# UNITED STATES PATENT AND TRADEMARK OFFICE

APPLICATION NO.	FILING DATE	FIRST NAMED INVENTOR	ATTORNEY DOCKET NO.	CONFIRMATION NO.
10/659,395	09/11/2003	Youichi Konno	031141	3764

## Office Action Summary

**Roth et al Fig. 32A**

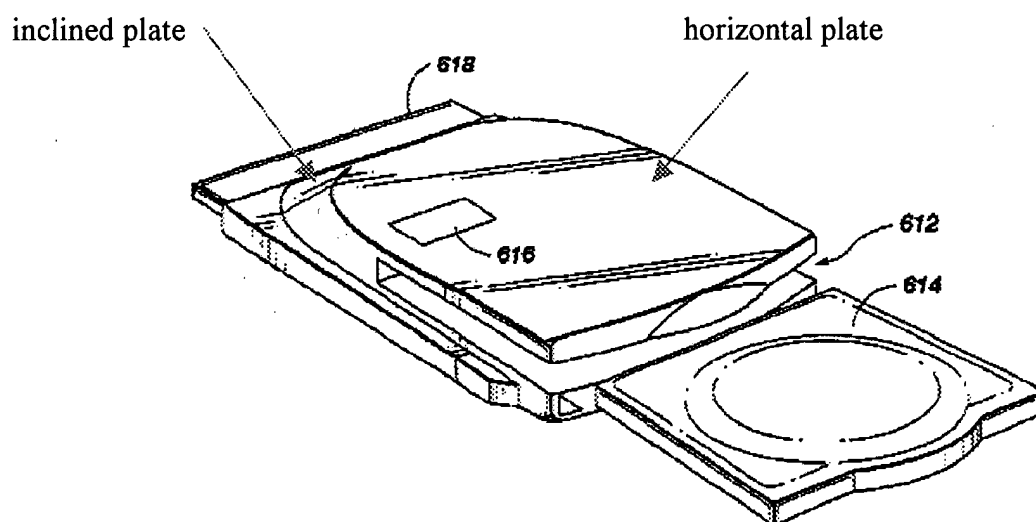
As recited in claim 1, Roth et al show a disk drive (see Figs. 32A-B) comprising: a main unit (upper left in 32A) which comprises a disk-driving unit (inherent) for rotating a disk, a data-

reproducing unit 616 for reproducing data from the disk, and a drive unit (inherent) for moving the data-reproducing unit relative to the disk; and an outer case which has a horizontal plate opposing the main unit and an inclined plate (see Fig. 32A) extending from a rear edge of the horizontal plate, gently inclining and covering the rear part of the main unit.

Roth et al show the claimed connectors 618, wherein the inclined plate is in the vicinity of the connectors (see Fig. 32A).

As recited in claim 4, it appears that the inclined plate of Fig. 32A is flat in at least one region, such that the claim is anticipated.
